**SUBJECT: NRC ACCEPTED VERSION OF IMPROVED BPWS CONTROL ROD INSERTION  
PROCESS LTR, NEDO-33091-A**

**NEDO-33091-A  
Revision 2  
Class I  
DRF 0000-0008-3745  
July 2004**

# **Improved BPWS Control Rod Insertion Process**

**SUBJECT: SAFETY EVALUATION FOR LICENSING TOPICAL REPORT (LTR)  
NEDO-33091, "IMPROVED BPWS CONTROL ROD INSERTION PROCESS"  
(TAC NO. MB9642)**

FIGURE 4.6-2  
 CONTROL ROD DRIVE UNIT

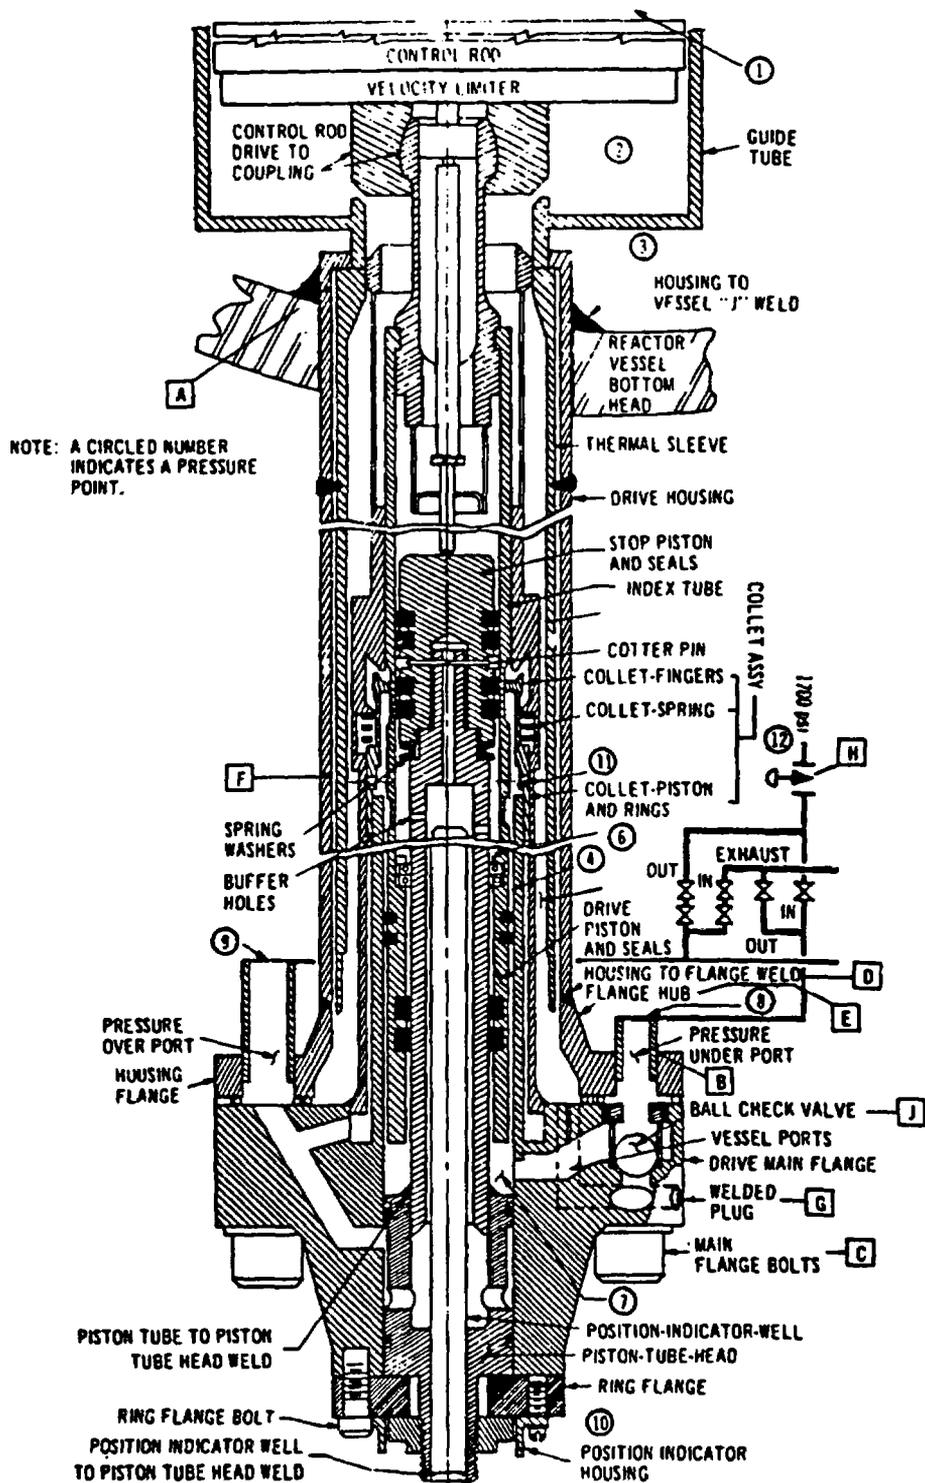
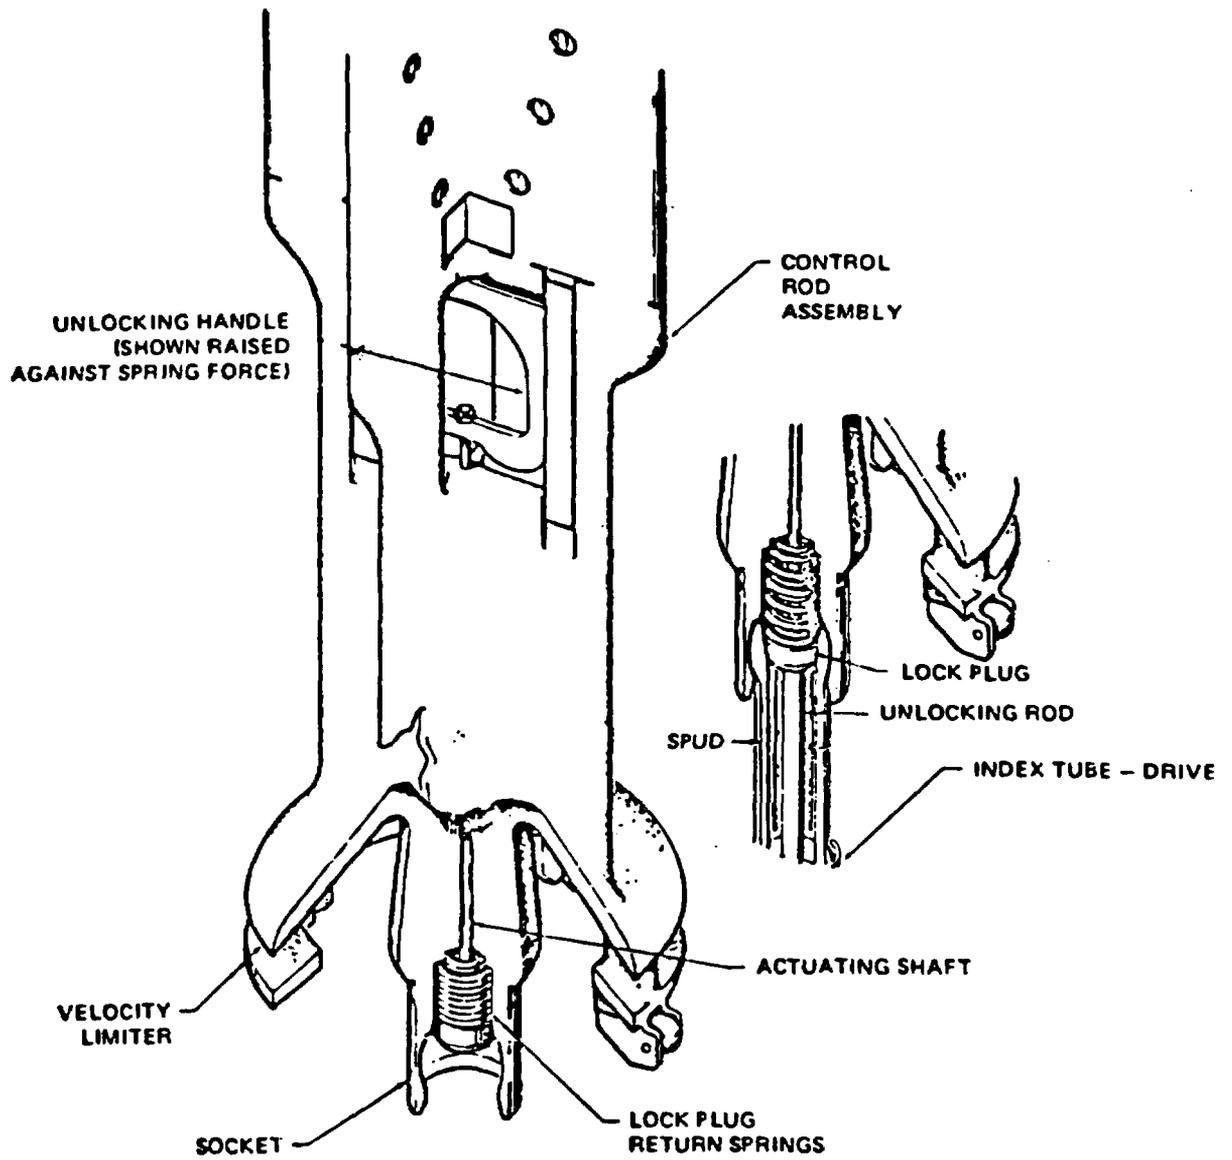
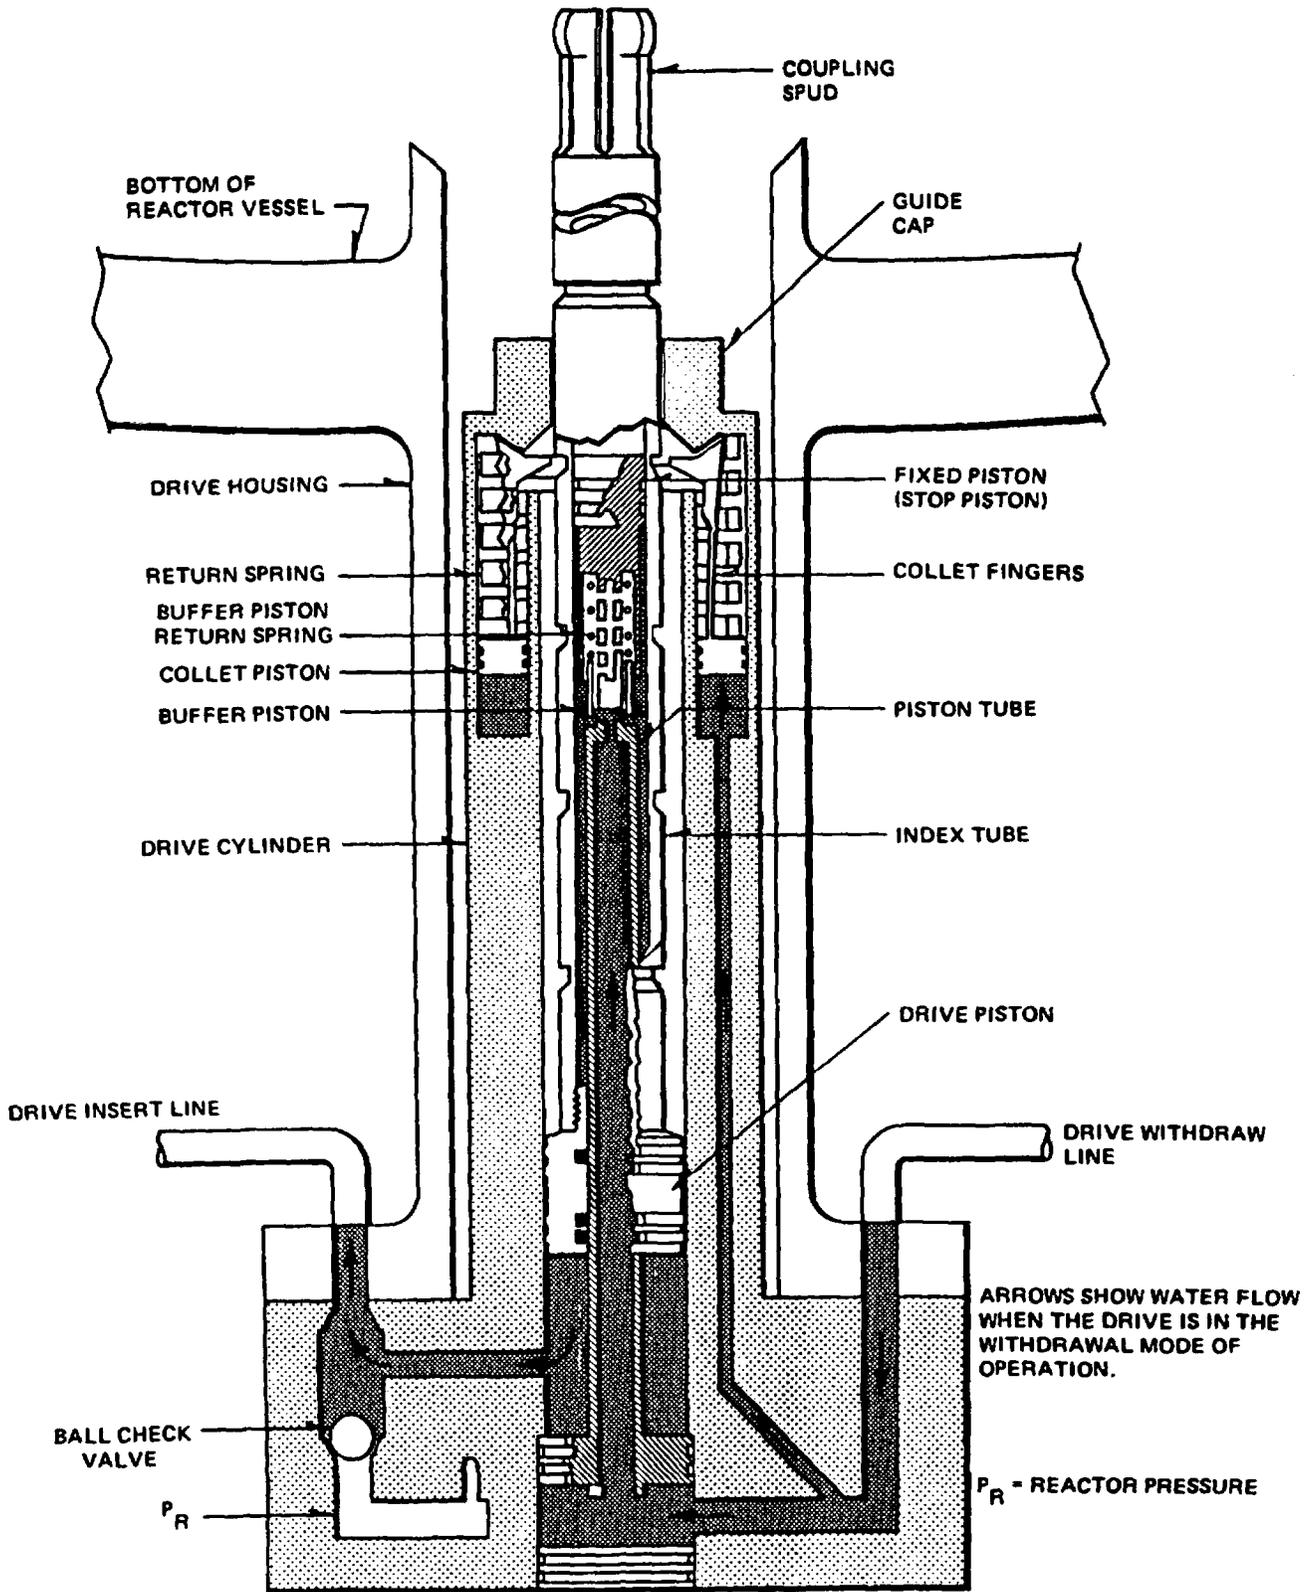
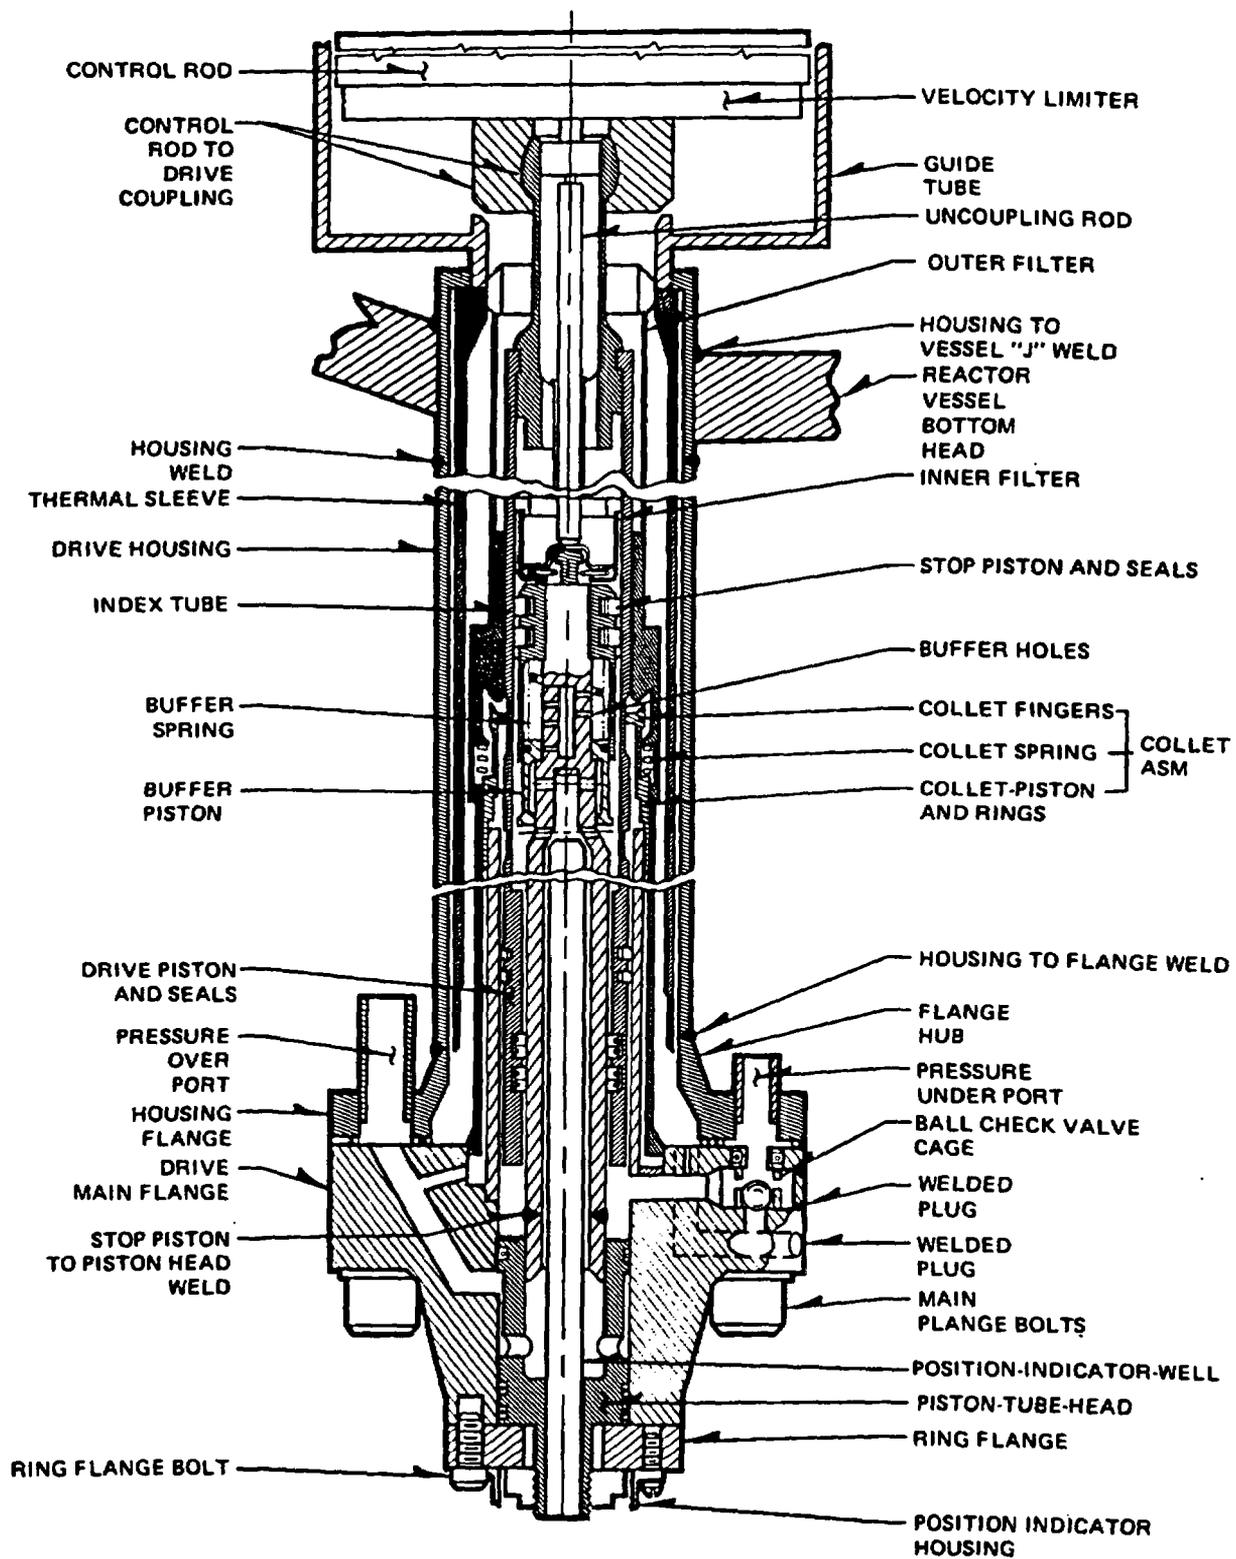
1. The LTR states that it is impossible for a control rod to become decoupled during the shutdown process following the improved BPWS. Please provide detailed information about the different types of control rod drives (CRDs) used for BWR-2 to BWR-6 plants with respect to the coupling between the CRD and control rod during shut-down. Based on this information, please also explain why it is not possible for the CRD and control rod to be decoupled.

All Reg. Guide 1.70, Rev.3 BWR UFSARs contain failure mode and effects analyses (FMEA) for the CRD system. Attachment 1 includes some pages from the FMEA in a typical BWR UFSAR (i.e., Limerick). As stated in the last paragraph of page 4.6-18, no single failure can of itself initiate a rod withdrawal. This statement is even more applicable, when the collet fingers are locked, such as when there is no CR movement or the CR is being inserted. (See Limerick Figure 4.6-3.) For a CR to withdraw, the six collet fingers must be unlocked so that the index tube can be lowered without being latched to a stop by the collet fingers. During CR insertion, if a mechanical/hydraulic failure occurs that stops all upward hydraulic force, the most the CR could withdraw is 6 inches to the next index tube latching indentation.

Attachment 1 also provides the UFSAR Control Rod Drive (CRD) and Control Rod (CR) design figures for a BWR/2 (Oyster Creek), BWR/3 (Monticello), BWR/4 (Limerick), BWR/5 (La Salle) and BWR/6 (Perry). For all BWR/2-6 plants, these figures demonstrate that a CR sits atop its associated CRD, and that it is physically impossible for a CR to move down past (i.e., to be withdrawn) its CRD.

Normally, a CR cannot become uncoupled from its CRD, because the CRD spud ("6-fingers") mechanically locks into the CR socket, and operator action is required to unlock this coupling. It is possible, due to a CRD assembly error, for a CRD to not properly lock into CR. In this case, CR movement (withdrawal and insertion) and scram are not impaired, because gravitational force will maintain the CR on top of its CRD. Plant Technical Specifications already provide provisions for coupling checks and steps to be taken if a CR is uncoupled from its drive.
